Suzanne Gronemeyer
Fermilab

Peter Gollon
Brookhaven

Corrected Values for Shielding Calculations

An updated version of the Fermilab Radiation Guide will soon be issued. Table 1 of Chapter 12.1 will reflect changes in the columns for thick soil and thick concrete in accordance with TM-664 and the CASIM booklet, "High Energy Particles Interactions in Large Targets". These changes were proposed by Peter Gollon of Brookhaven, the original author of Chapter 12, in a letter (attached) to Suzanne Gronemeyer of Fermilab dated October 27, 1982.

FIG 2, TM-266

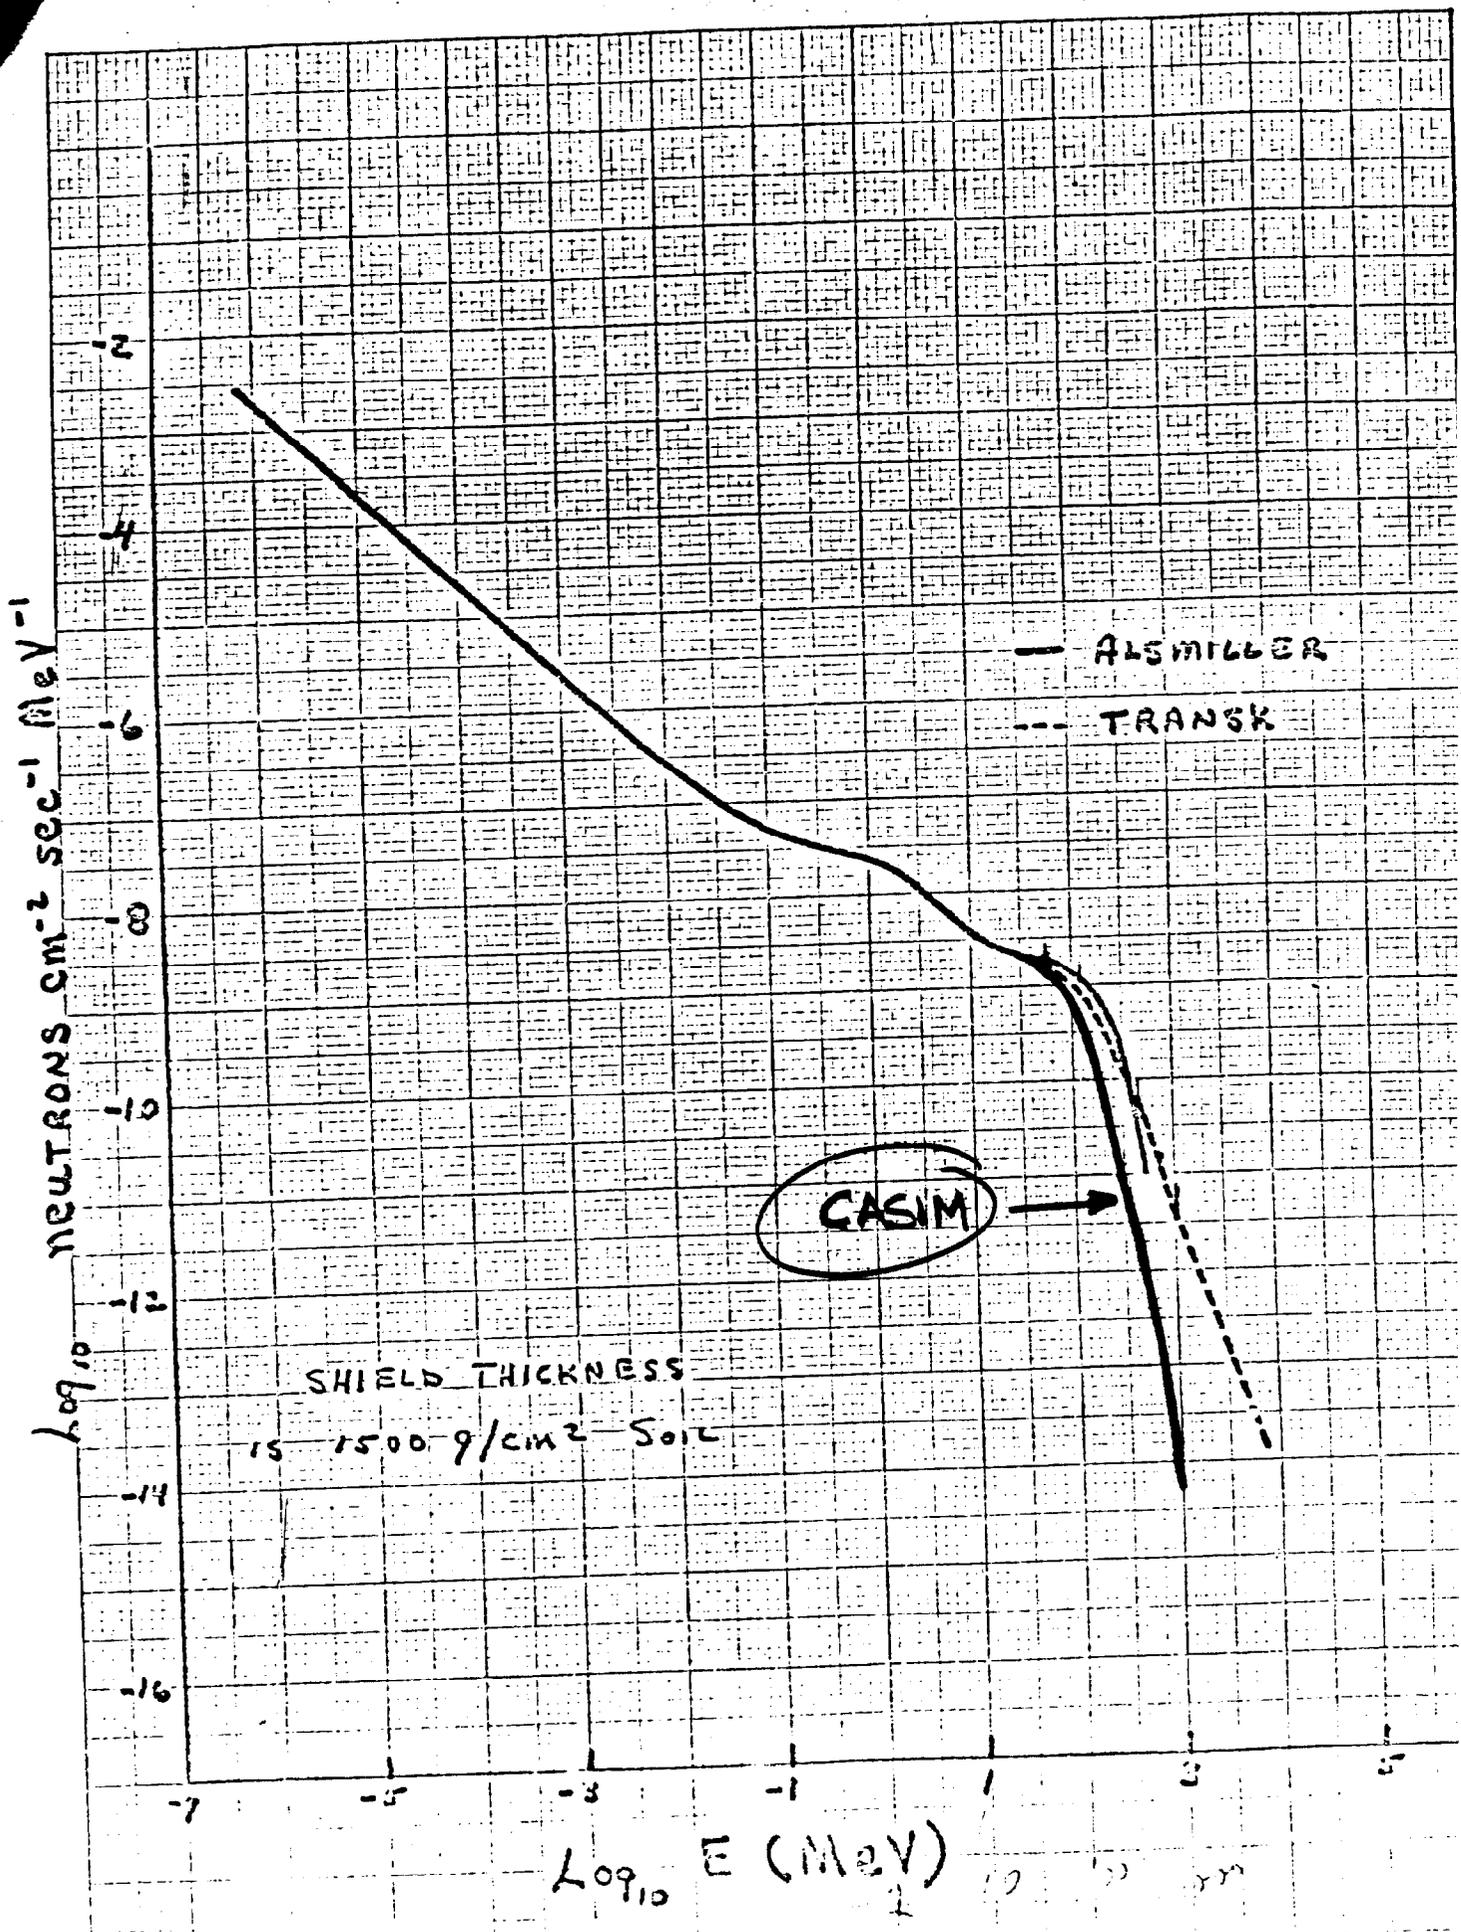
What conversion factor did he use to get ~~from~~ TO:

TN 266 neutrons
Fig 2 $\text{cm}^2 \text{sec} \text{meV}$

from: VIII . 32 stars ?
 $\text{cm}^2 \frac{\text{GeV}}{c} \text{incp}$ •

Peter converted momentum ($\frac{\text{GeV}}{c}$) to KE (MeV)

to make the conversion from
Andy's plot to TN-266 Fig 2

Peter picked off

300, 500, 1000, 1800 $\frac{\text{MeV}}{c}$ pts from VIII . 32

=> 47, 124, 430, 1087 MeV assuming
 $m = m_{\text{neutron}}$

Also ordinate change:

$$\frac{\text{flux}}{\rho \frac{\text{MeV}}{c}} \rightarrow \frac{\text{flux}}{\text{MeV}}$$

must transform momentum intervals to kinetic energy intervals (in addition to abscissa change)

Peter "spliced" ^{CASIM} ~~ASIM~~ (normalized) to Alsmiller & ~~TRANSK~~ TRANSK arbitrarily @ ~30 MeV
Didn't do CASIM at lower energies

His Fig from Fig 2. TM 266 is irrelevant

Table 1 takes data from 2 different sources.
He proposes to throw out #s from TM 266.
His Fig 2-TM 266 is a consistency check.
